Increasing donor-acceptor spacing for reduced voltage loss in organic solar cells

REVIEWER COMMENTS

Figure R1. J_{sc} simulated by transfer matrix simulations for the DCDA solar cells with different active layer thicknesses. The optical constants of the materials used in the solar cells are measured by spectroscopic ellipsometry.

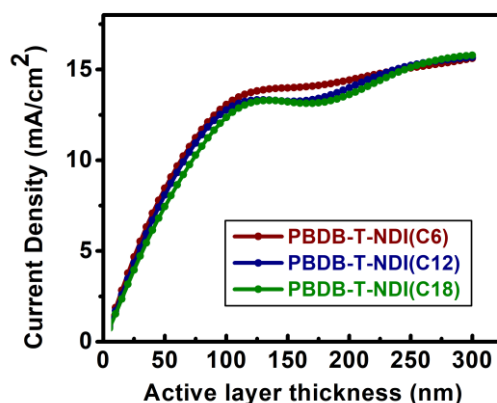
3. In figure S1.3.b, PBDB-T-NDI(12) shows the lowest absorption coefficient among these three polymers. However, it delivers the highest PCE and J_{sc} . Can the author make a discussion on this phenomenon as the charge transfer of these polymers are all efficient and the driving force are comparable (estimated from $(E_gCV-ECT)/q$).

Our response: To understand the reason for the different J_{sc} of the solar cells based on the different DCDA polymers, transfer matrix model (TMM) simulations, done using the measured dielectric functions of the materials used in the solar cells (*J. Appl. Phys.* 1999, 86, 487), are now included in the revised manuscript. The results from the TMM simulations

We find that the J_{sc} predicted by the TMM are similar for all of the DCDA solar cells. This suggests that the difference in the measured J_{sc} of the solar cells is a result of different device internal quantum efficiencies (IQEs). For organic solar cells, IQE is primarily determined by the dissociation efficiency of the S_1 state into free charge carriers and their extraction efficiency. Since we found from the PL measurements (**Figure S8.1**) that the S_1 dissociation efficiency is high (over 90%) in all of the DCDA polymer based films, the lower IQE of the solar cell based on PBDB-T-NDI(C6) with the shortest linker, as compared to that based on PBDB-T-NDI(C12) and PBDB-T-NDI(C18), is most likely due to less efficient charge carrier extraction. This could also explain the strongly field dependent photocurrent extraction in the solar cell based on PBDB-T-NDI(C6) (**Figure S9.1**). In this work, we demonstrate that the decay rate of CT state is very high for the solar cell based on PBDB-T-NDI(C6), it is thus reasonable to attribute the rather inefficient photo-conversion to the high decay rate of the CT state, resulting in a comparably low IQE and low J_{sc} in the solar cell based on PBDB-T-NDI(C6).

For the solar cells based on PBDB-T-NDI(C12) and PBDB-T-NDI(C18), the extraction of photocurrent is independent of electric field (**Figure S9.1**). This suggests that in PBDB-T-NDI(C12) and PBDB-T-NDI(C18), the CT state decay rate, which is reduced as compared to that of PBDB-T-NDI(C6), does not limit the J_{sc} . Also, it suggests that the slightly lower J_{sc} of the solar cell based on PBDB-T-NDI(C18), as compared to that based on PBDB-T-NDI(C12), is due to a less efficient dissociation of excitons. PL measurements (**Figure S8.1**) reveals that quenching of the acceptor emission is indeed less efficient in the active layer based on PBDB-T-NDI(C18), as compared to that based on PBDB-T-NDI(C12). This could be a result of a relatively higher degree of aggregation of the acceptor units in the film of PBDB-T-NDI(C18), due to the higher degree of spatial freedom of the acceptor units in the DCDA polymer with longer linkers.

Figure R2. A three-state model describing the decay of free charge carriers (k_{FC}), the generation (G), dissociation (k_{diss}), and decay rate (k_{CT}) of CT states in a DA system.

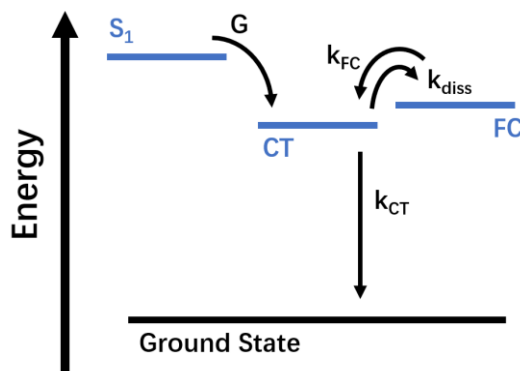
3) The transient voltage decay measurements should be explained in more detail (information in the SI is not enough). Why does the voltage decay time represent the lifetime of the photogenerated charges (i.e. the CT decay rate)? Does it not rather depend on extraction and free charge lifetime?

Our response: The voltage decay time does depend on the lifetime of free charge carriers, but extraction efficiency of charge carriers is irrelevant in the transient voltage decay measurements, because the measurements are done for the devices under an open-circuit condition: no charge carriers are extracted in the device under an open-circuit condition.

The relationship between the life time of charge carriers and the lifetime of CT states has been discussed in the literature (*Annu. Rev. Phys. Chem.* 2016. 67(113), 33), and more recently, in (*J. Phys. Chem. C* 2021, 125, 15590). Here, this relationship is simplified using the three-state model (**Figure R2**), in which the lifetime of charge carriers (τ_{FC}) is determined by the decay (k_{CT}) and the dissociation rate (k_{diss}) of CT state, as well as the decay rate of free charge carriers (k_{FC}), i.e., the rate of free charge carriers falling into CT states.

$$\tau_{FC} = \tau_{CT} + 2N\tau_{diss} \quad (\text{eq. R16})$$

where τ_{CT} is the lifetime of CT state, which equals to the inverse of the product of k_{CT} and N_{CTC} ; and τ_{diss} is the time needed for the CT state to dissociate into free charge carriers, which is the inverse of the product of k_{diss} and N_{CTC} . Therefore, the key determining factor for τ_{FC} (voltage decay lifetime determined by the TPV measurement) is τ_{CT} and τ_{diss} , and τ_{FC} linearly increases with τ_{CT} .
